MODEL BD-700-1A10 (BD-700)

**MODIFICATION – CONTROL AND INDICATION SYSTEMS –  
 REPLACEMENT OF SFCU WITH PART NO. GT415-5900-17**

**SERVICE BULLETIN:** 700-27-061      **ISSUE:** Basic      **DATED:** Dec 01/2008

Reference of Torque Tube Initial Position  
Figure 1

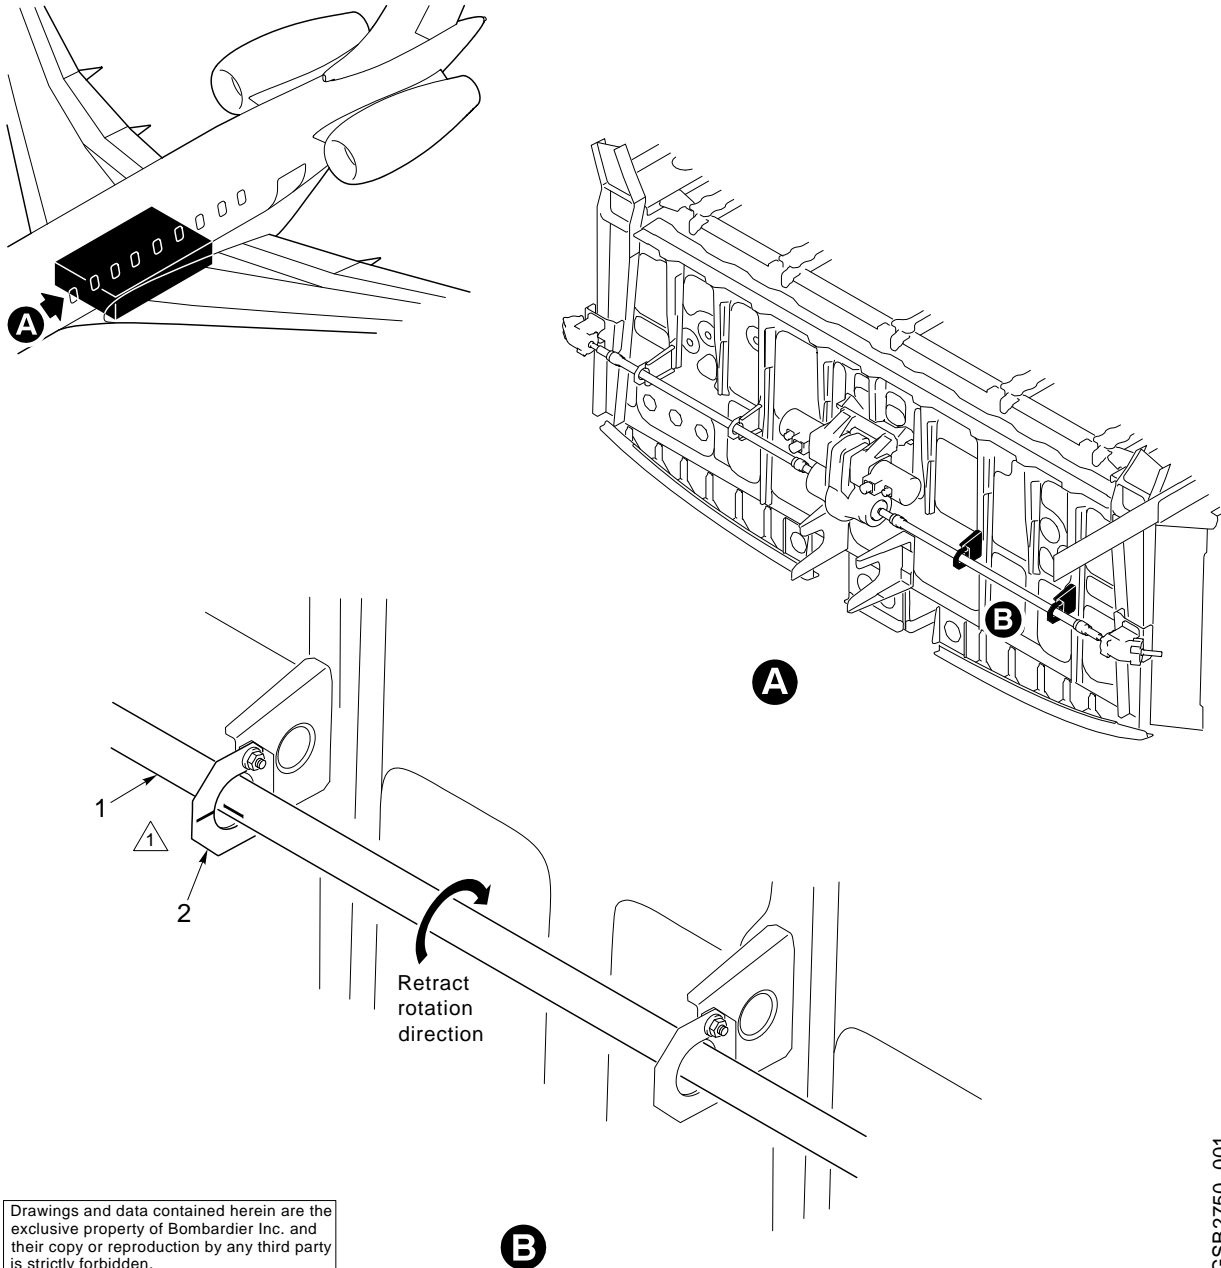
- (6) Do the rigging of the slat system as follows:
- (a) In the CAIMS PMAT, do as follows:
    - (i) Go to SYSTEM DIAG to get ATA SELECTION DISPLAY page (1/2).
    - (ii) Go to ATA 27-00 FLIGHT CONTROLS to get the LRU SELECTION PAGE.
    - (iii) Go to SLAT/FLAP CONTROL UNIT #1 to get the STORED FAULTS DISPLAY/LRU TEST page.
    - (iv) Go to LRU TEST to get the SFCU 1 LRU TEST MENU 1/1.
    - (v) Go to SLAT RIGGING – SFCU 1 to get the SFCU 1 SLAT RIGGING – PAGE 1/4 screen.
    - (vi) Go to CONFIRM to get the SFCU 1 SLAT RIGGING – PAGE 2/4 screen.
    - (vii) Go to SLAT RIG ENABLE COMMAND and push SELECT.
    - (viii) The indications LEFT/RIGHT SLAT RESOLVER (DEG) should show  $20.0 \pm 10.0$  degrees.
  - (b) Put reference marks on the left hand or right hand torque tube and on the adjacent pad to record the initial position of the torque tube. Refer to Figure 1.

- (v) Go to RELEASE R SLAT MOTOR BRAKE.
  - (vi) Go to SELECT.
  - (vii) Go to RELEASE L SLAT MOTOR BRAKE.
  - (viii) Go to SELECT.
- (d) Retract the slats panels by manually rotating the torque tube until you reach the mechanical stop and record the number of turns required. Refer to Figure 1 for rotation direction.

- NOTE: The mechanical stop must be reached within 0.5 to 1.5 turns from the reference marks previously made.
- (e) Return the torque tube to the initial position.

Steps Measurement  
Figure 2

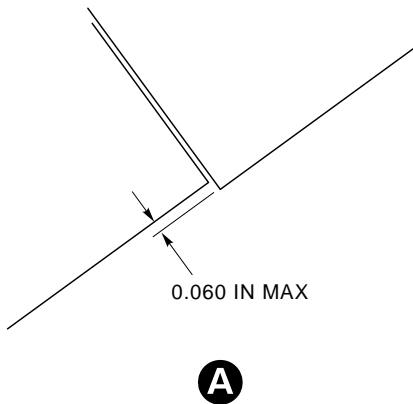
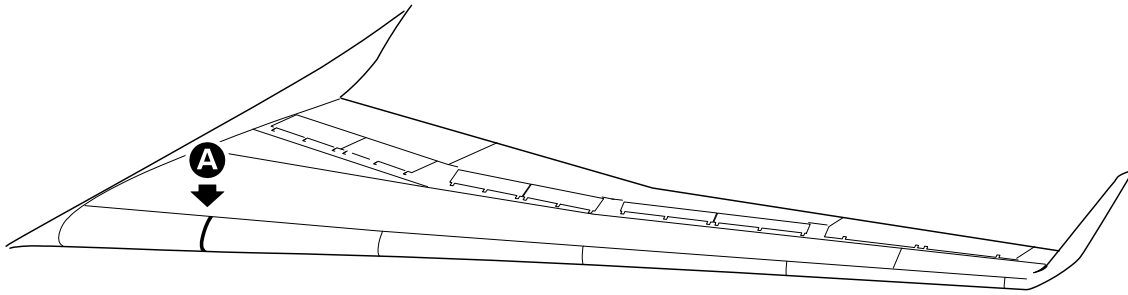
- (f) Measure the step between the leading edge of the No. 1 slat panel and the wing fixed leading edge. Refer to Figure 2.
- (g) If the step between the leading edge of the No. 1 slat panel and the wing fixed leading edge is greater than 0.060 in (1.52 mm), do as follows, if it is less go to the next step (h):

- (i) Manually rotate the torque tube until the step between each leading edge of the No. 1 slat panel and the wing fixed leading edge is 0.060 in (1.52 mm) or less and record the number of turns required.

- NOTE: The new reference position must remain within 0.5 to 1.5 turns from the mechanical stop.
- (ii) If the step requirement cannot be obtained within 0.5 to 1.5 turns from the mechanical stop, refer to TASK 27-53-00-820-801.
